AGENDA PORTLAND PLANNING BOARD MEETING

PLANNING BOARD REPORT PORTLAND, MAINE

Nine Residential Units and Cafe
1006 Congress Street
Level III Site Plan and Subdivision
PL-000444-2018
1006 Congress Street, LLC, Applicant

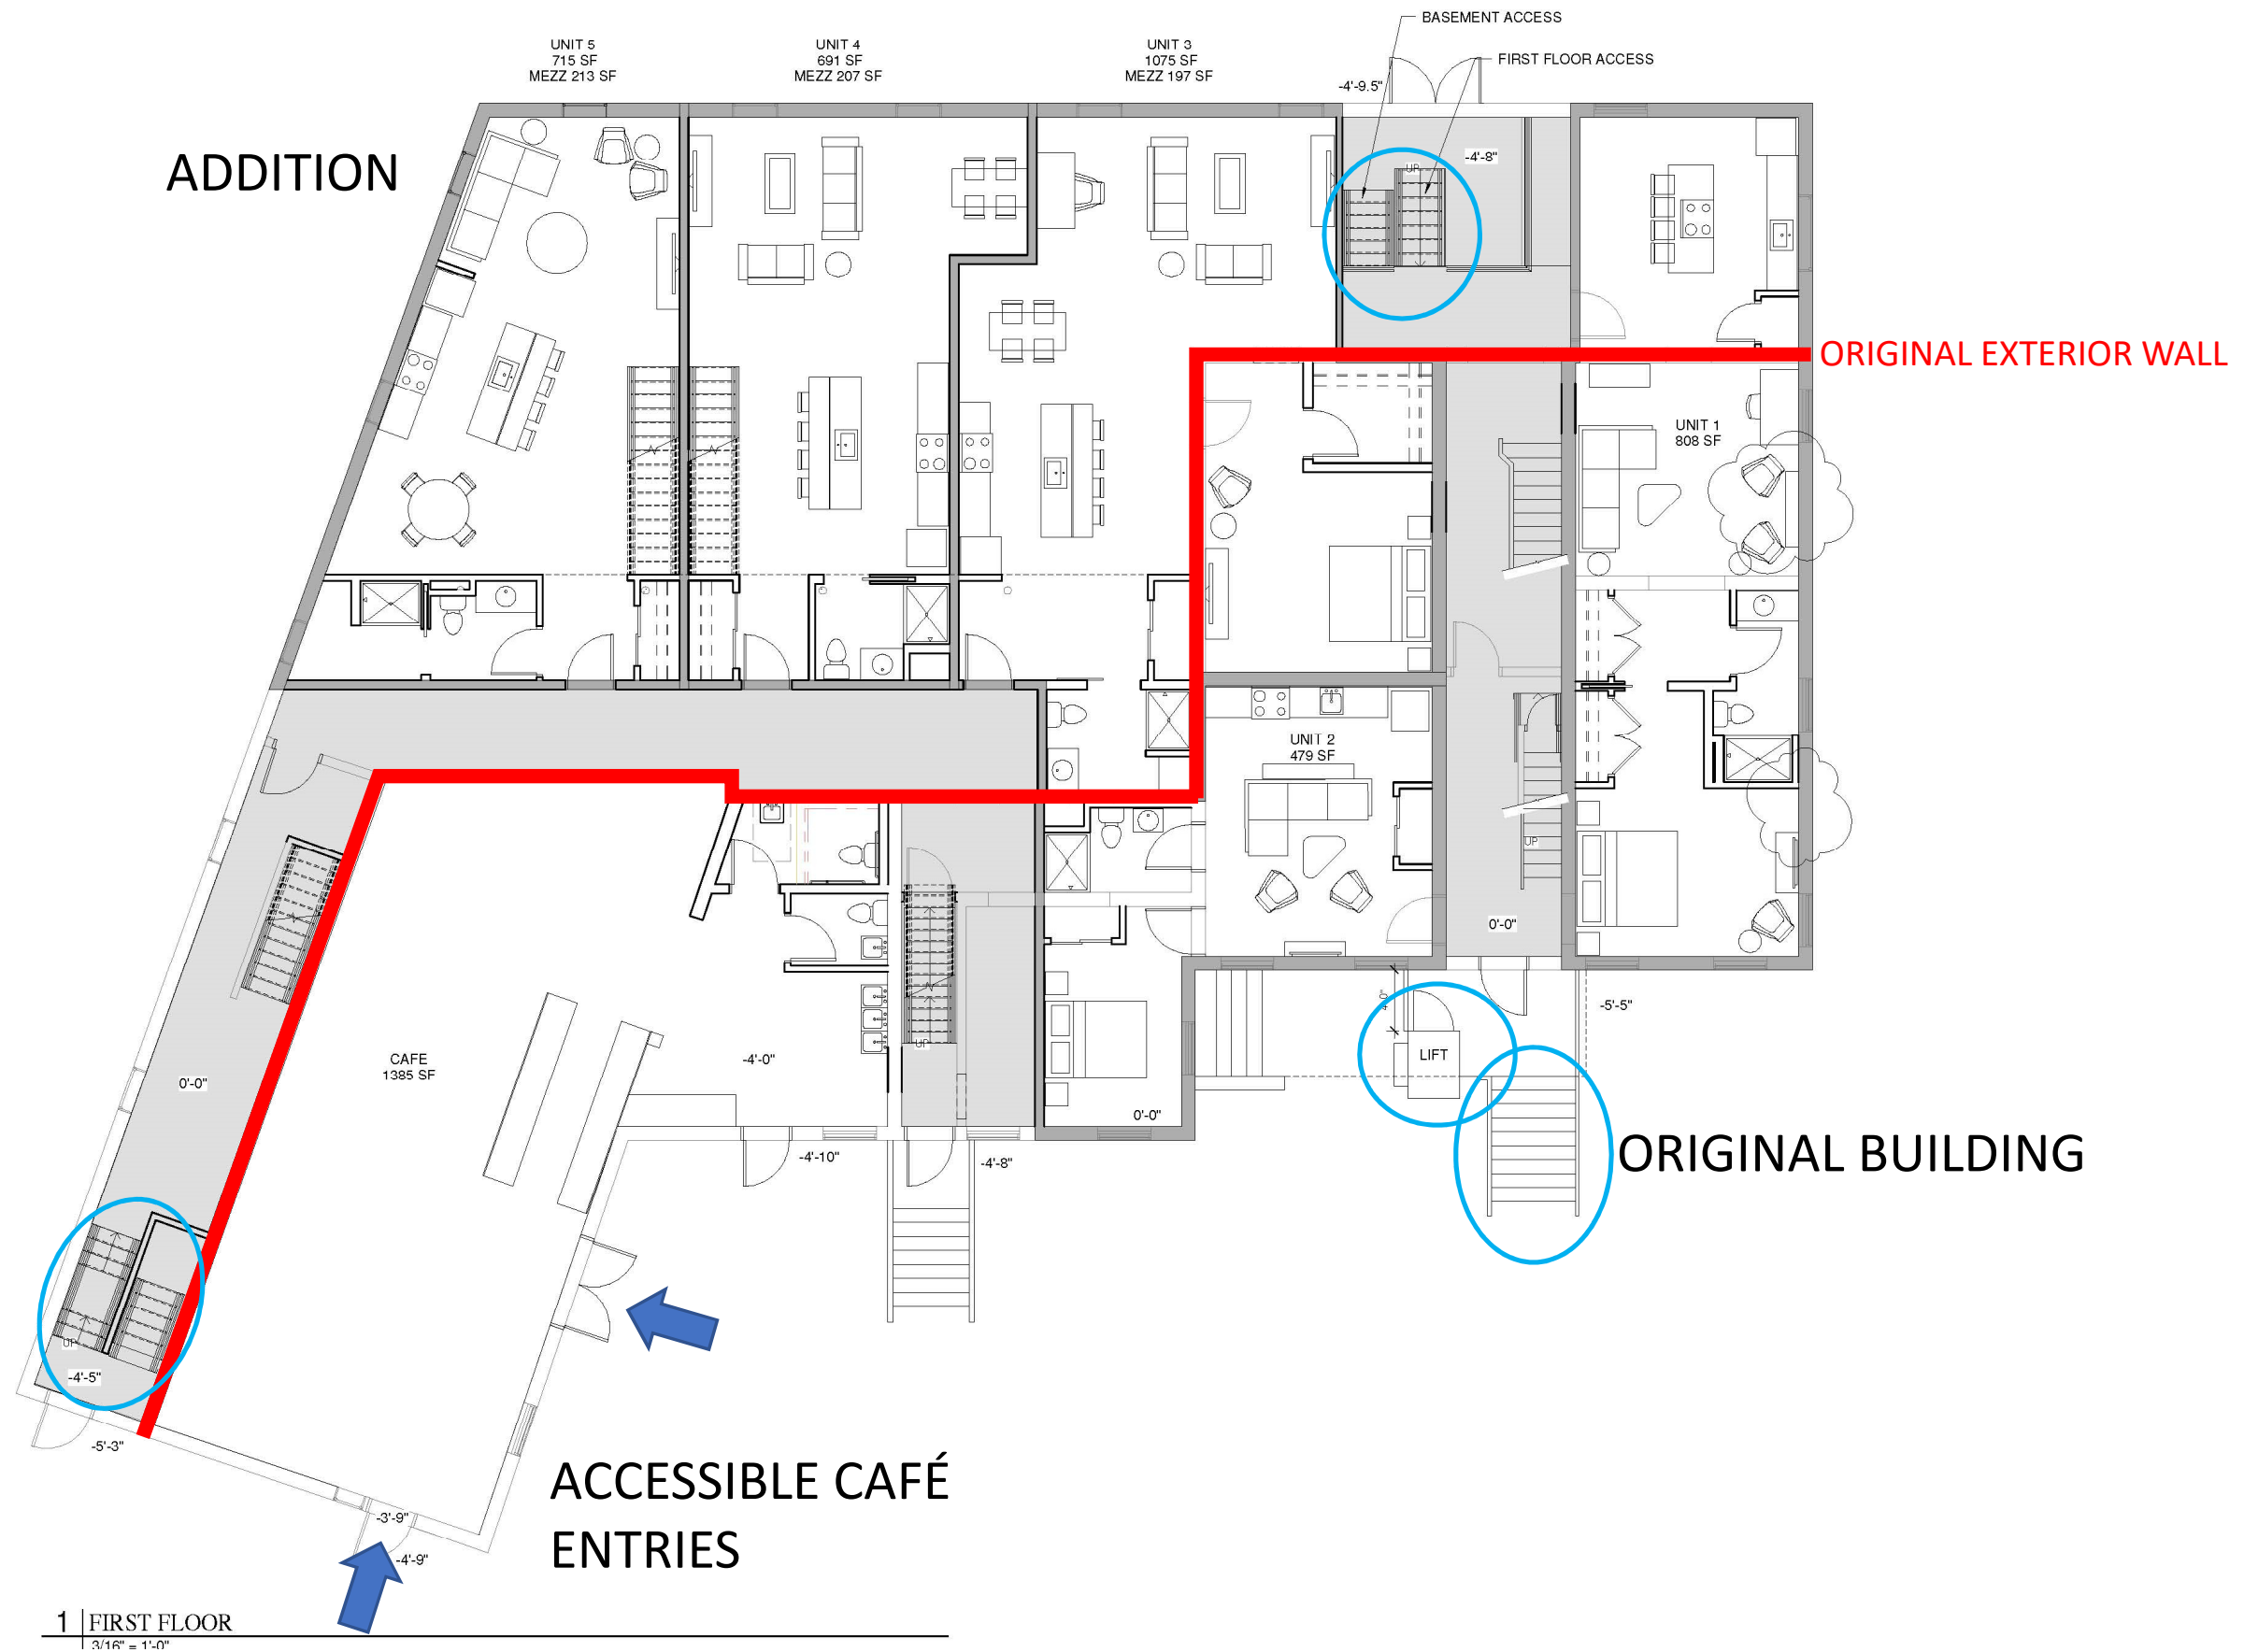
The entrances have been revised. Originally the building was being repurposed as business uses but has more recently been re-designed as apartments and a café. With the new uses the previous entries have been differentiated to designate them as residential or public – the café.

It has been questioned why the café is located at the inner portion of the building rather than right along Commercial Street as guided by the design standards. There are several factors that led to this placement. Some of the included documents help to diagram the explanation.

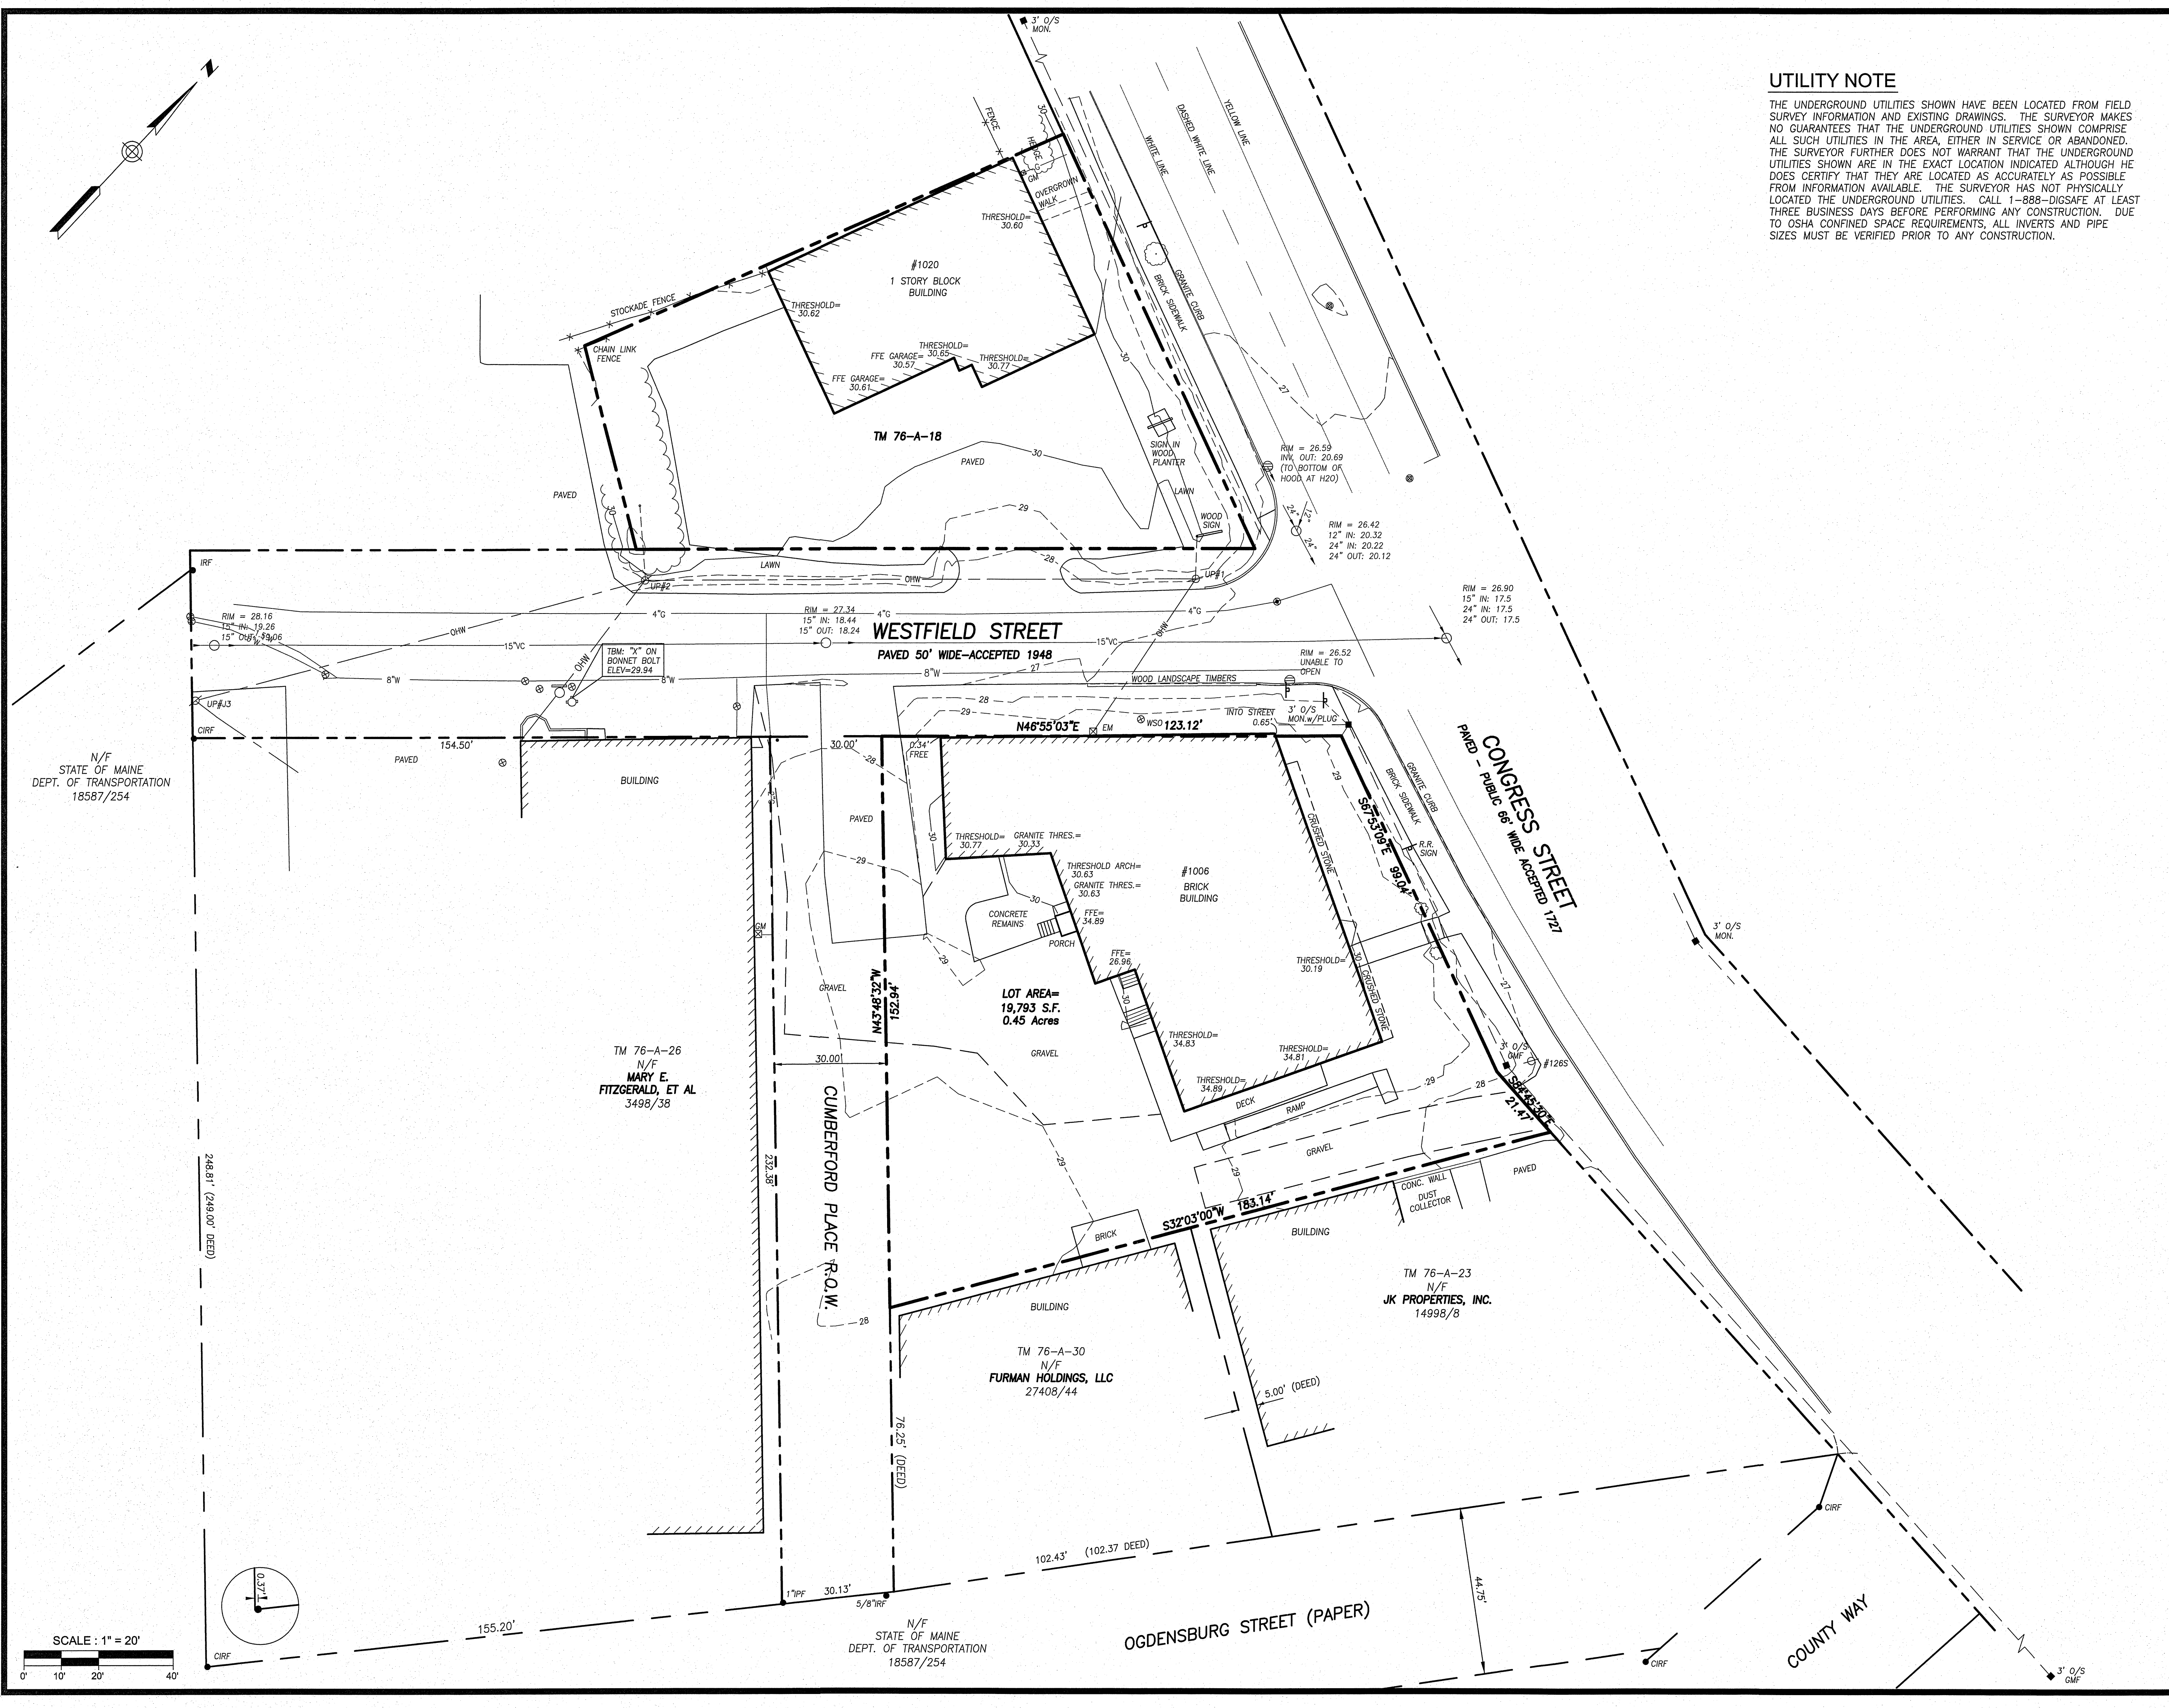
Site & Utility Plan Sheet C3.0

- An ADA-compliant pedestrian access route (**minimum 5'**) across the easterly driveway at Congress Street is not evident given the configuration of ramps and driveway shown (see Detail Sheet C6.0 comments)
